City of Sandy

Parks & Trails Advisory Board Meeting

Meeting Date: Wednesday, June 8, 2022

The Parks Board should discuss the following topics. These questions were submitted by the developer as part of the Vista Loop Subdivision Pre-Application document (Attachment A).

PROJECT: THE BORNSTEDT VIEWS
TENTATIVE PLAT MAP

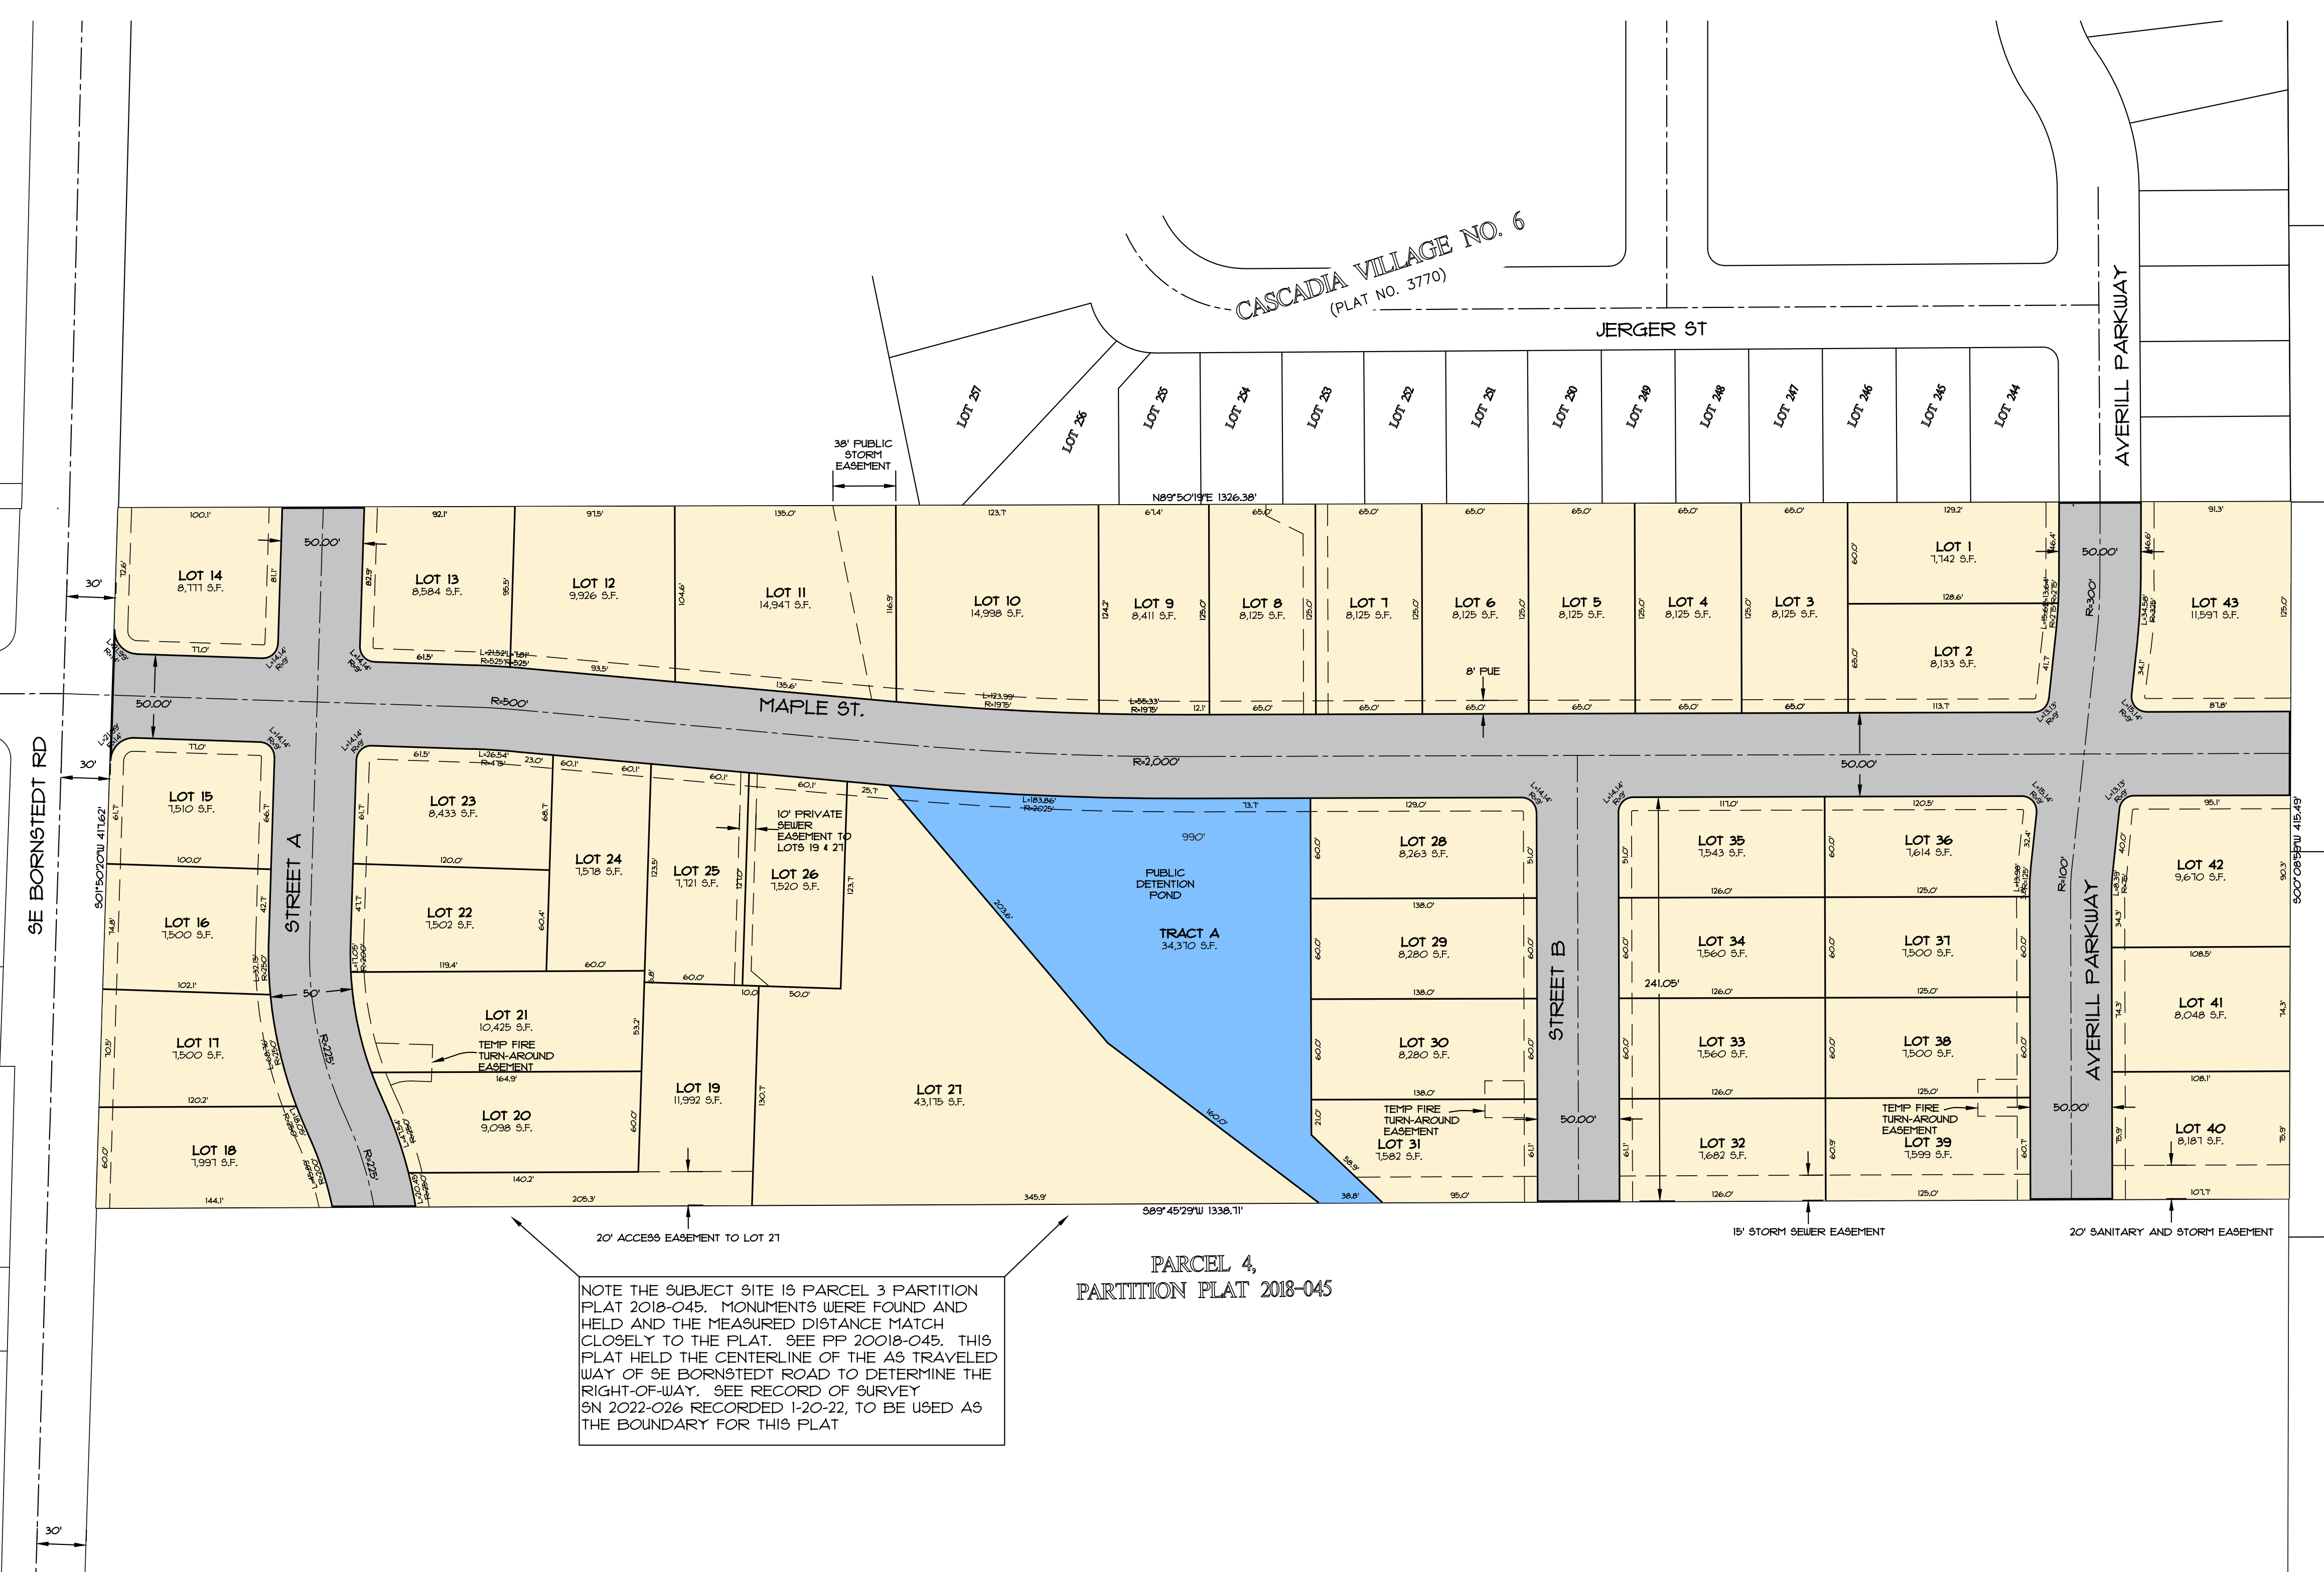
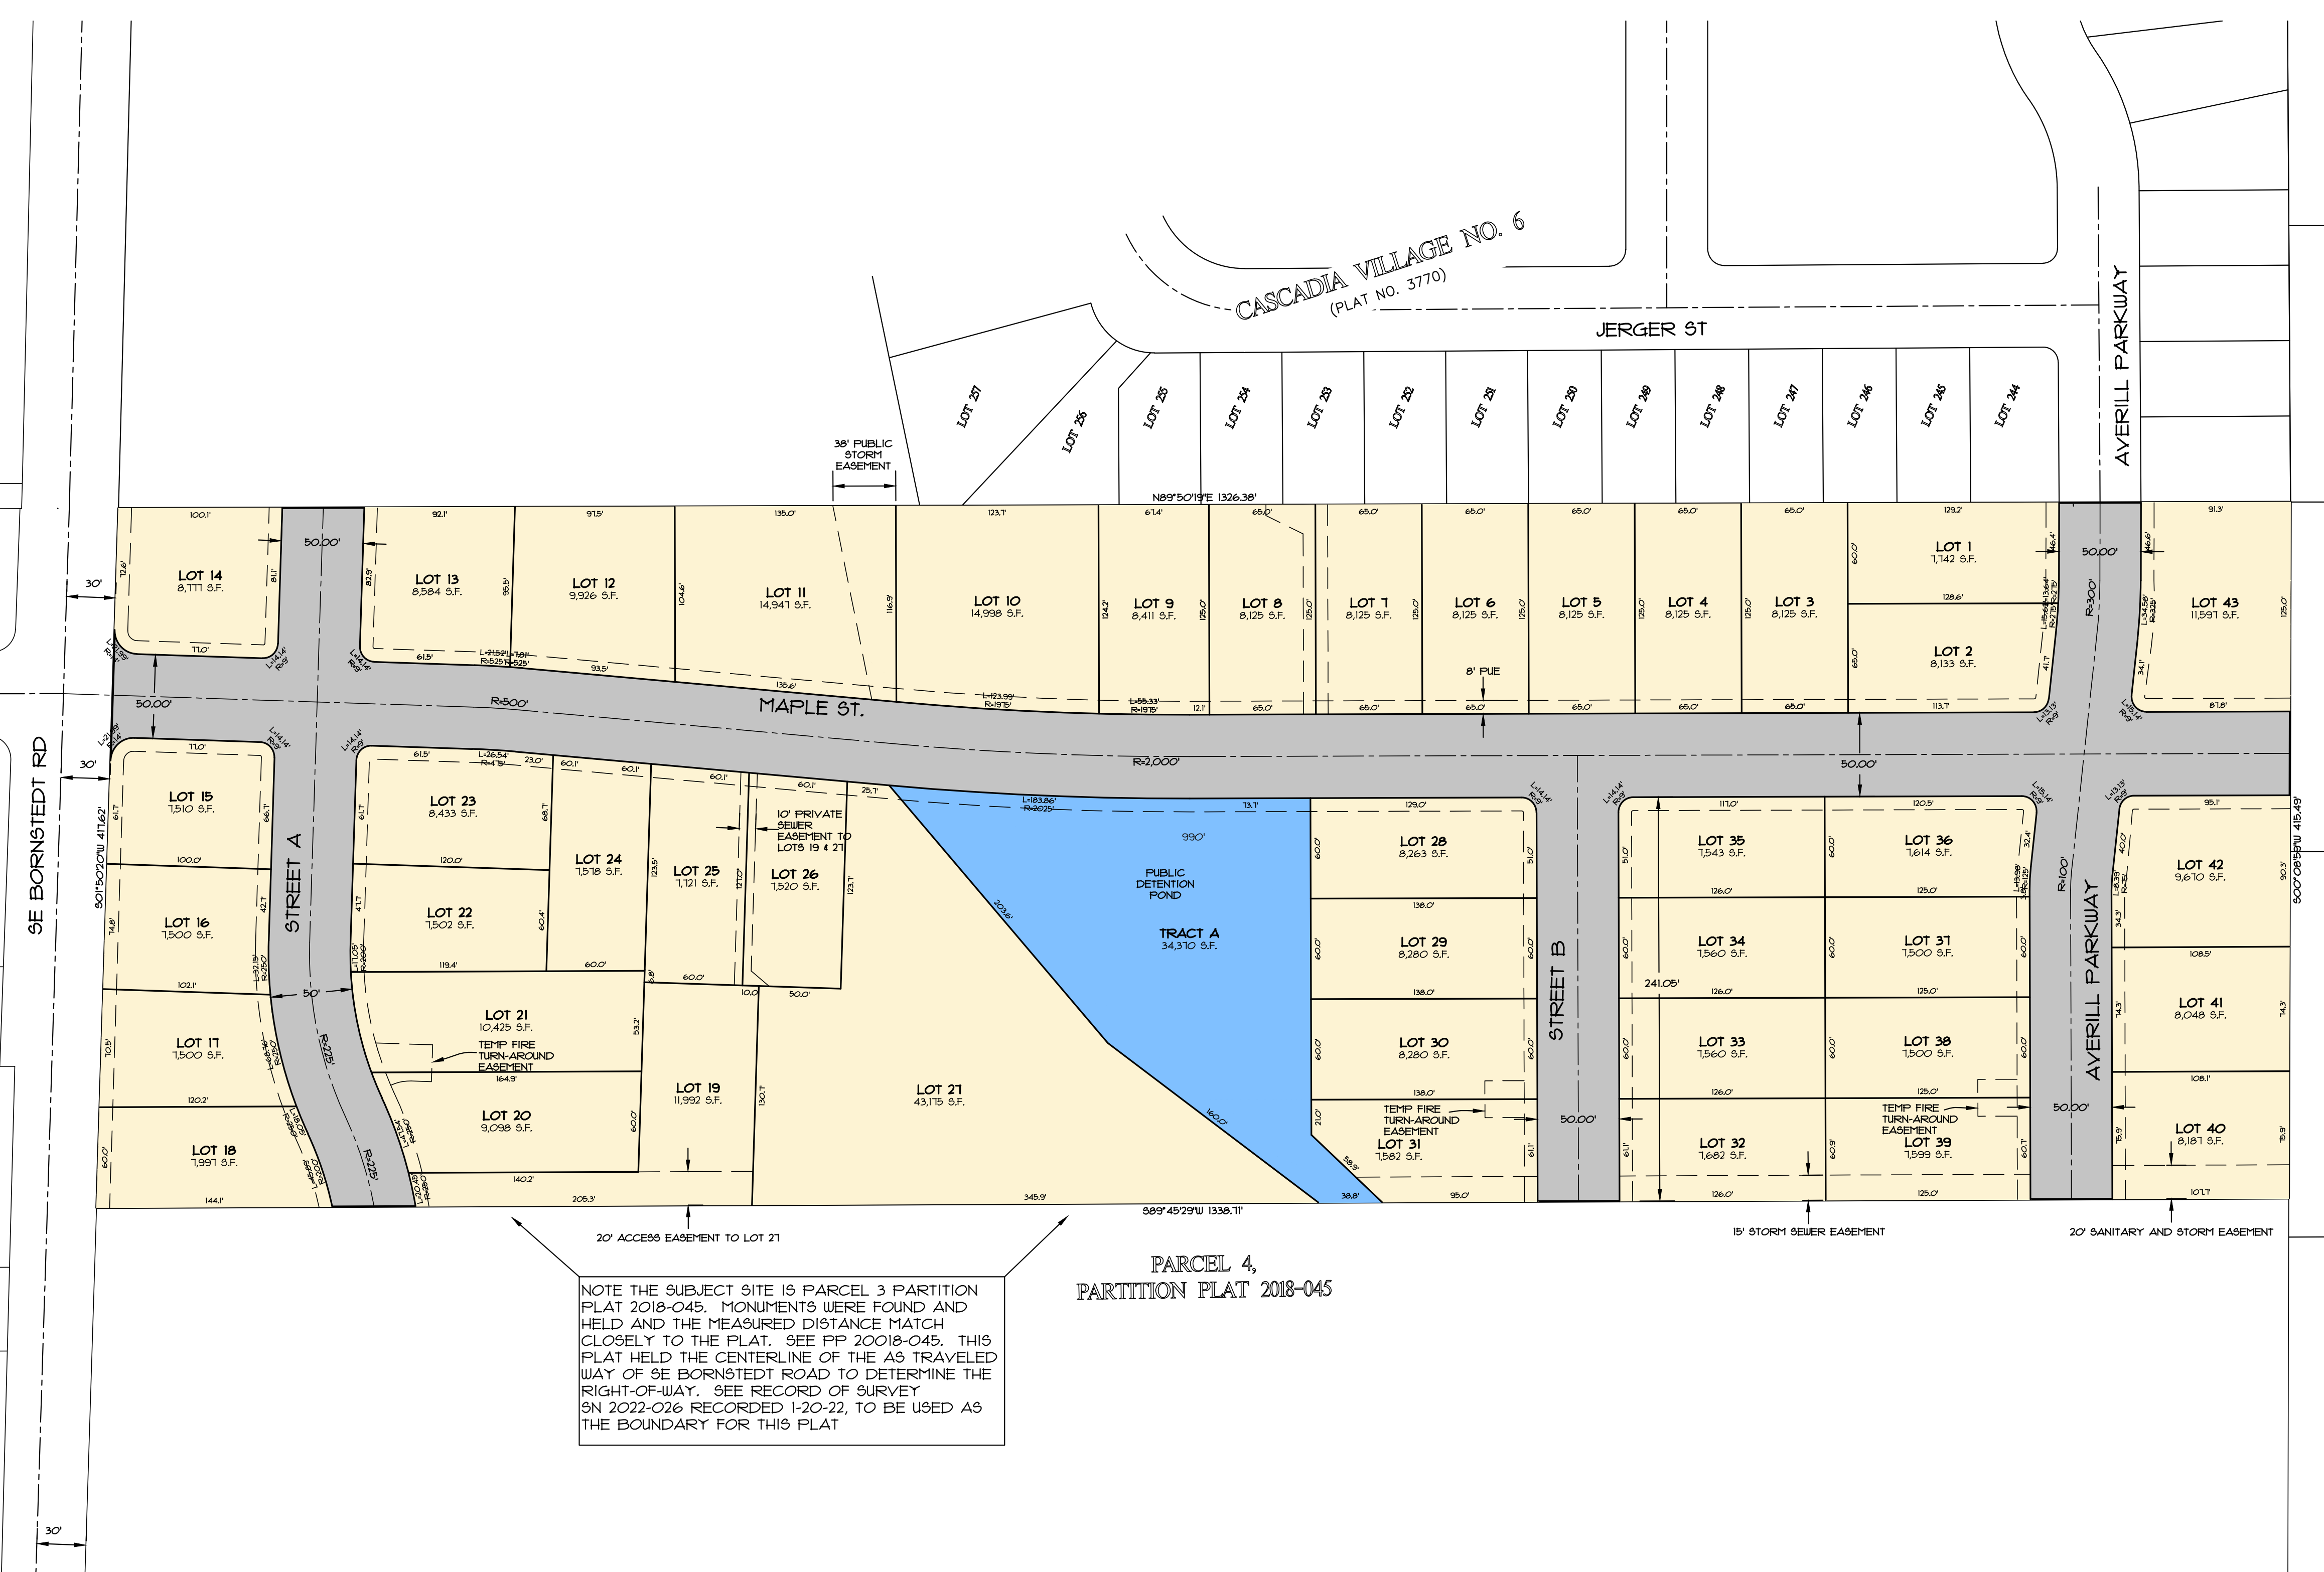
18. Section 17.100.60(D) outlines the data requirements for a tentative plat. Section 17.100.60(D.5) requires the applicant to detail existing and proposed right-of-way. The submitted Tentative Plat Map (Exhibit C, Sheet C2) details 30 feet of right-of-way from the centerline of Bornstedt Road to the property line. The Bornstedt Road section (Section B) on the Street and Utility Plan (Exhibit C, Sheet C8) details a 60 foot total right-of-way and a

new right-of-way line on the east side of the road. Based on the partition plat for Marshall Ridge Subdivision (Plat 4603; Exhibit T), Planning and Public Works staff believe the total right-of-way width along the Bornstedt Road frontage of the site varies in width from 83.06 feet at the northern property line to 96.21 feet at the southern property line of the Marshall Ridge Subdivision. Staff requested the chain of title for the property and did not find any evidence of Clackamas County granting the property owner additional right-of-way. The submitted tentative plat map is not accurate and does not adequately detail existing and proposed right-of-way. The Public Works Director (Exhibit Q) states that the tentative plat does not appear to comply with the minimum accuracy requirements in Section 17.100.60(D). Staff finds the application does not meet the submittal requirements of Section 17.100.60(D.5).

28. The applicant proposes constructing 42 single-family dwellings or duplexes as permitted in this zoning district. Section 17.34.30 contains the design standards for this zone. As shown on Sheet C2 of the plan set (Exhibit C), all lots in the proposed subdivision contain at least 7,500 square feet and contain an average lot width of 60 feet as required.
